WOLF CREEK
NUCLEAR OPERATING CORPORATION

ET 05-0016

Subject: Docket No. 50-482: Response to Request for Additional Information – Extensions of AC Electrical Power Distribution Completion Times

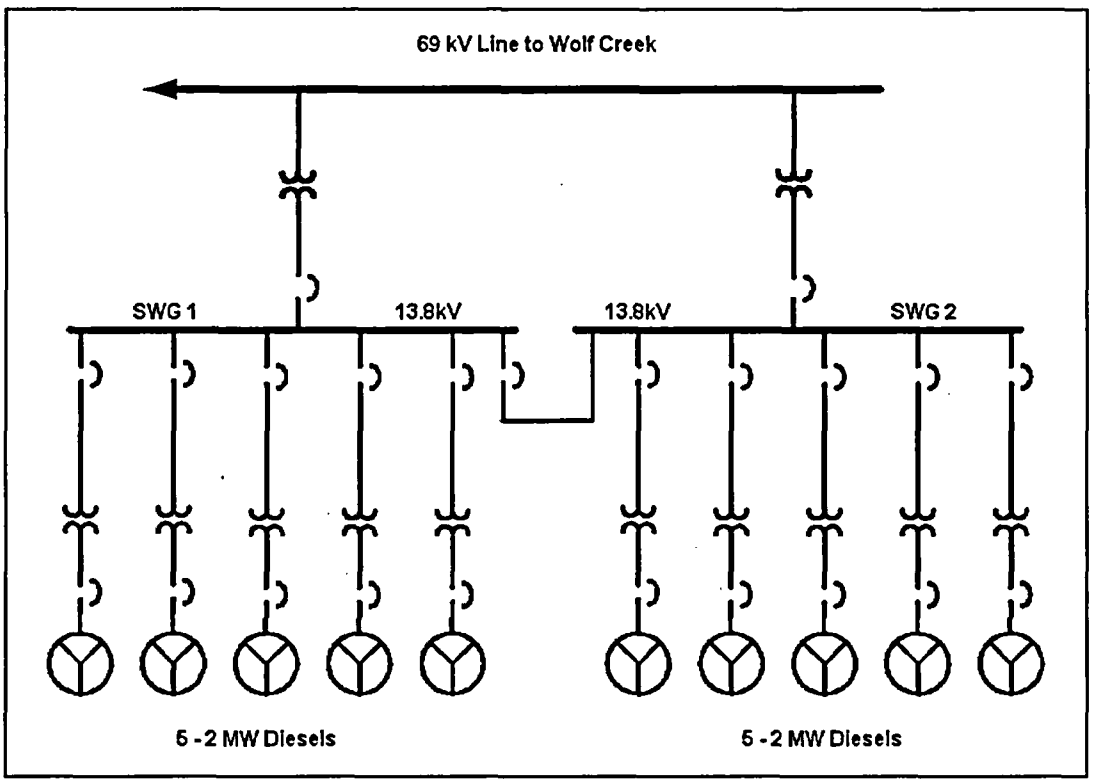
25. The licensee's response to RAI 7 provided in attachment 2 to its application states: "...Due to the Sharpe station design, common cause is not an important contributor of failure to deliver power to the emergency plant equipment..." Describe the Sharpe station design which makes common cause an unimportant contributor of failure to deliver power to the emergency plant equipment.

Sharpe Station consists of ten, two-megawatt Caterpillar 3516B engine-generator sets (gensets). They are arranged in two banks of five with separate transformers. The gensets are sited at a single location proximate to an existing 69 kV substation near Sharpe, Kansas, approximately two miles north of Wolf Creek. A "Simplified One-Line Diagram of Sharpe Station Power to WCGS" on page 4 of Attachment I to WO 03-0057 shows the relationship of Sharpe Station to the WCGS Switchyard and the ESF busses (NB01, NB02). The WCNOC emergency diesel generators are of the Fairbanks Morris-Colt Pielstick PCV2.5 design and the Sharpe Station gensets are Caterpillar 3516B design. Based on the above, there are no commonalties between the WCGS DGs and the Sharpe Station gensets. A more detailed one-line layout of the gensets at Sharpe Station is shown below.

Severe weather that impacts the WCGS switchyard can be postulated to affect the normal offsite power sources and the Phillips 69kV (Lyon-Coffey REC) line. To minimize this possibility, WCNOC intends to perform the extended DG maintenance period during time frames that historically have demonstrated low severe weather frequency. Favorable weather periods also tend to avoid time periods of high grid demand. Prior to entering the planned DG maintenance, weather forecasts for severe weather predictions will be checked. If the forecast is not favorable, the maintenance will be delayed or rescheduled as appropriate. Other external events, such as flooding and transportation do not constitute significant hazards to the generating station due to its distance from major highways and water sources.

Four (4) gensets are required to support one safety bus with LOCA loads. This becomes the basis for the success criteria. Common cause is a very minor contributor to Sharpe Station failure, given the total number of gensets available, the number of gensets required for LOCA loads, and the station configuration.
